SECTION 009111 - ADDENDUM NUMBER 2

- 1.1 **DATE: FEBRUARY 2, 2026,**
- 1.2 **PROJECT: SHERIDAN PUBLIC LIBRARY BUILDING ADDITION, RENOVATIONS & SITE IMPROVEMENTS:**
- 1.3 **PROJECT NUMBER: 25050**
- 1.4 **OWNER: SHERIDAN PUBLIC LIBRARY, 103 W 1ST STREET, SHERIDAN, IN 46069**
- 1.5 **ARCHITECT: ODLE MCGUIRE SHOOK MATTHEW R. MAYOL #IN19900090**

E201

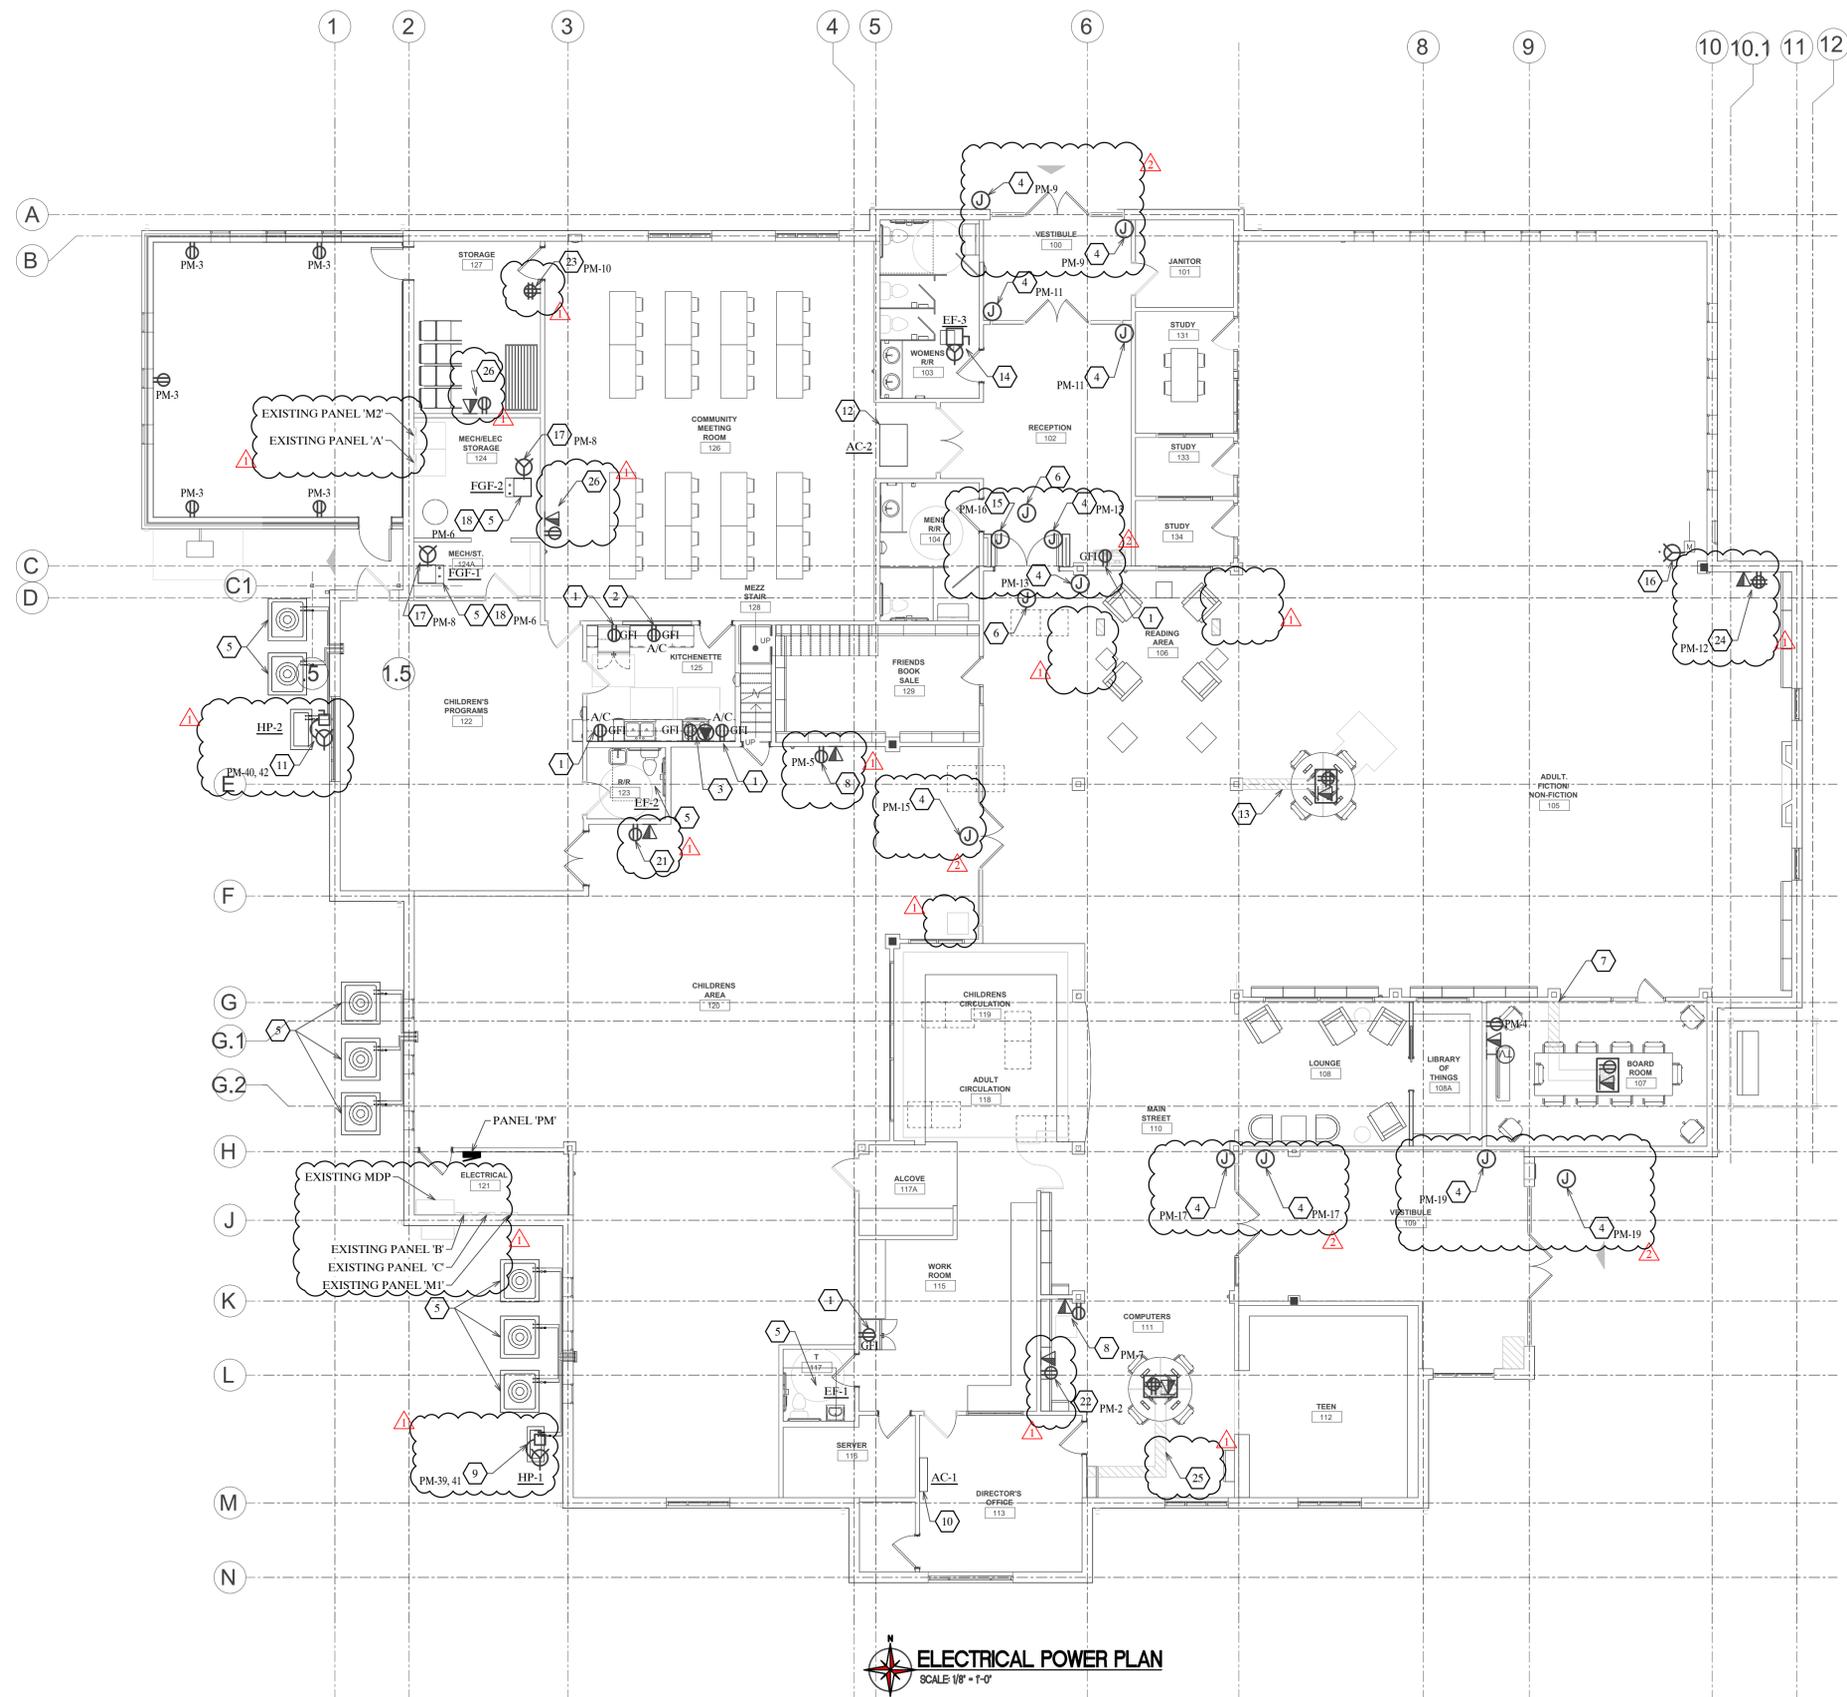
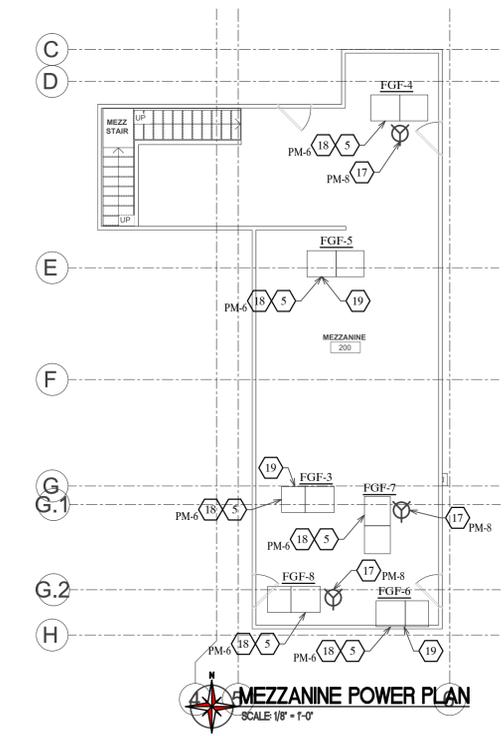
5.10 E201 ELECTRICAL POWER PLANS

- A. Refer to Triangle 2 notations
